Detailed Site Plan Alternative Compliance Advance Auto

DSP-21034
AC-23003

REQUEST	STAFF RECOMMENDATION
Construction of a 6,889-square-foot building for a vehicle parts or tire store.	With the conditions recommended herein: <ul style="list-style-type: none">• Approval of Detailed Site Plan DSP-21034• Approval of Alternative Compliance AC-23003

SUBJECT: Detailed Site Plan DSP-21034
 Alternative Compliance AC-23003
 Advance Auto

Figure 1: Site Plan

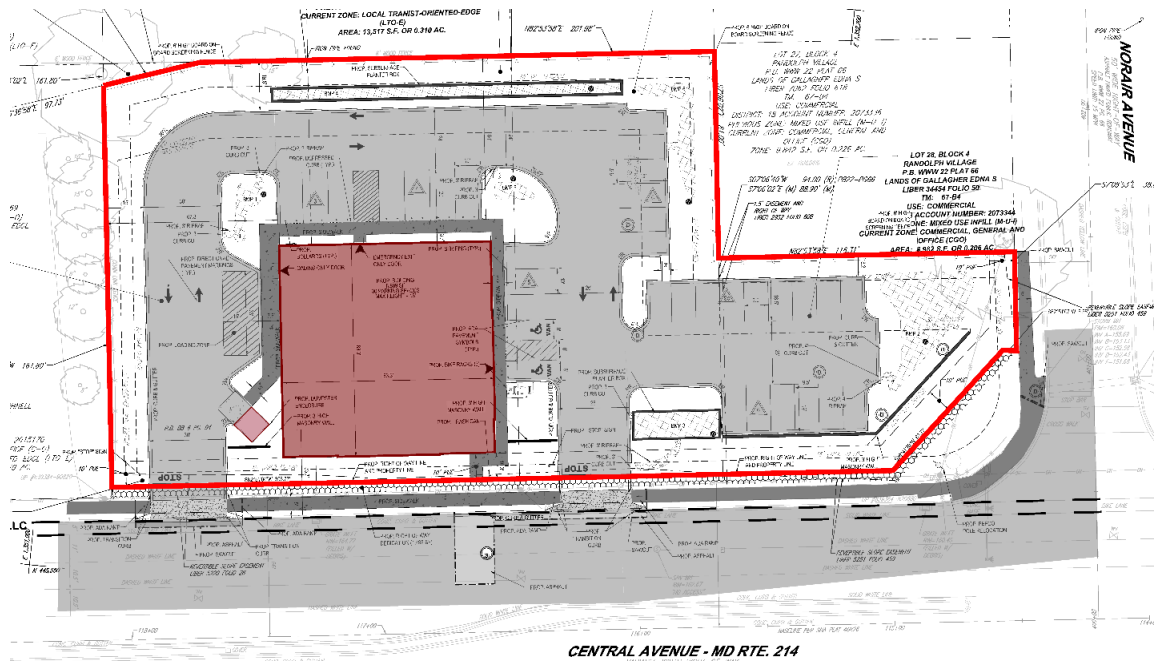
6. **Design Features:** The applicant proposes to construct a 6,889-square-foot building, for a vehicle parts or tire store without installation facilities. The building is located at the intersection of MD 214 and Norair Avenue. The building is oriented towards and has pedestrian and vehicular access from MD 214. No vehicular or pedestrian access is provided from Norair Avenue, given the narrow frontage of the property along this street. The building is one-story and approximately 23 feet in height. While the building is oriented towards MD 214 to the south, the main pedestrian entrance and lobby are located on the east elevation of the building facing Norair Avenue.

The building is accessed by two driveways on MD 214, both of which are limited to right-in/right-out only since a median exists on MD 214 which controls the flow of traffic. Parking is provided to the side and rear of the retail building, with handicap accessible parking located close to the entrance door. Bicycle parking is also provided near the entrance door, easily accessible from both the public sidewalk along MD 214 and the internal parking lot.

The proposed streetscape includes a 5-foot-wide sidewalk along the frontage of MD 214 and Norair Avenue, and a 5-foot-wide bicycle path along the frontage of MD 214, per the recommendations of the master plan. A 5-foot-wide lead walk connects the building entry way to the public sidewalk along MD 214. Stop signs and pavement markings are provided at both entrances, to ensure pedestrian safety at points of conflict with vehicular traffic. It is recommended that the crosswalks be designed with a contrasting material, color, or pattern, in addition to being striped to further accentuate the crosswalks.

The retail building is pushed as close to the build-to line as practicable, and the site frontage occupancy is extended using a 3-foot-high masonry wall in a complementary material. In addition, a landscape strip with planting, bicycle racks, and a trash receptacle are also proposed along the street frontage of MD 214 and Norair Avenue, to activate and ensure a lively streetscape. Both facades of the building facing MD 214 and Norair Avenue are accented by an awning, storefront glass windows, and a building-mounted sign. The primary facades and rooflines are articulated with brick-faced bump-outs which add visual interest. The service areas are located in the rear and side of the site and screened from direct public view. These facilities and design elements help the development to achieve the intent of the master plan, to ensure the creation of vibrant urban neighborhoods and an attractive, low-intensity functional employment area. The treatment of the street frontage also provides a pleasant and safe pedestrian experience.

- e. Provide decorative paving (e.g., scored, or stamped concrete) to distinguish the crosswalk in front of the two entrance driveways, subject to approval of the operating agency.

- f. On Sheet DSP-4, add labels indicating the location where the detail can be found for various site features (such as bollards, dumpster enclosure, masonry wall).

- g. Show the location of awnings on the site plan.
- h. Label the dimensions of the building bump-outs on the southern and eastern facades.
- i. Extend the masonry wall along the south side of the subsurface planter box located near the intersection of MD 214 (Central Avenue) and Norair Avenue.

- j. On Sheet DSP-4, show the location of all on-site pole-mounted light fixtures.
- k. On Sheet DSP-4, revise the Site Requirements as follows:
 - (1) Revise the building setbacks to reflect the required setbacks, in accordance with the 2010 *Approved Subregion 4 Master Plan and Sectional Map Amendment*.

Figure 4: Build-To Line and Setbacks exhibit from the master plan

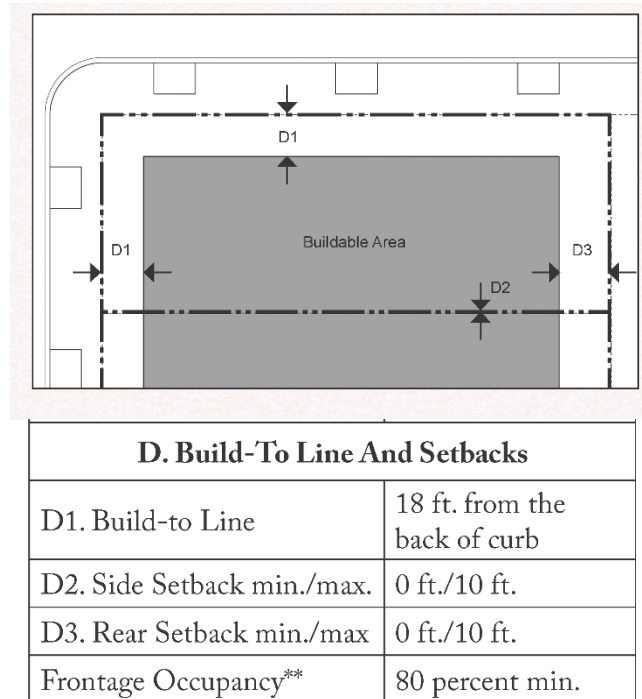
Due to the unique circumstances impacting the subject property, it is not possible to conform to these standards, necessitating a request for an alternate development district standard.

The proposed building is located 23.5 feet from the back of the curb. This setback requires an alternate development district standard. The setback is necessary to provide a 10-foot-wide public utility easement (PUE), which was not contemplated in the master plan, and does not permit any setbacks to the front build-to line. The PUE is required by Condition 3.a. of PPS 4-22042, which was approved for the subject property. Due to the requirement to establish the PUE, the applicant is not able to conform to the 18-foot build-to line requirement.

To the extent that the build-to line requirement also applies to Norair Avenue, the frontage along this street is limited to the extent that conforming to the build-to line on Norair Avenue is impossible. Also, the proposed building does not conform to the required 10-foot side and rear yard setbacks. The subject property is abutted by single-family detached homes. The 2010 *Prince George's County Landscape Manual*

In addition to the build-to lines and setbacks, a frontage occupancy requirement of 80 percent is established. The proposed building occupies 27 percent of the property frontage. However, two circumstances support granting this request for alternate standards. First, as noted above, the property has a narrow frontage on Norair Avenue, which does not have sufficient width to locate a driveway, much less a building. This narrow depth extends for a third of the subject property's frontage on MD 214 and practically prevents compliance with this standard. Two access driveways are also provided, which account for another 16 percent of the property frontage. Thus, strict conformance with this standard is not possible. However, the master plan allows the use of a masonry wall to help meet the frontage occupancy requirement when attached to the primary building. The applicant proposes to provide a 3-foot-tall masonry wall. The wall extends from the east and west of the building to each of the driveway aisles. The wall then extends along the remaining frontage of MD 214 to Norair Avenue. A total of 97 linear feet of wall is provided. However, the wall is not attached to the building, to allow for pedestrian circulation to the sidewalk on MD 214. The total distance of the wall, combined with the width of the building, brings the frontage occupancy to 58 percent. The applicant should provide a site elevation of the property, as visible from MD 214 and Norair Avenue, to demonstrate how their proposed 3-foot-high wall, landscaping, and lighting will benefit the development and mitigate the impact of the requested alternate standards.

Based upon the above justification, the proposed development complies with the intent and spirit of the requirement. The requested alternate standards will benefit the development and the development district and will not substantially impair implementation of the master plan. These modifications will not negatively impact the project or alter the intent of the standard to construct buildings close to the street. Therefore, staff recommend **approval** of these requested alternate development design standards.
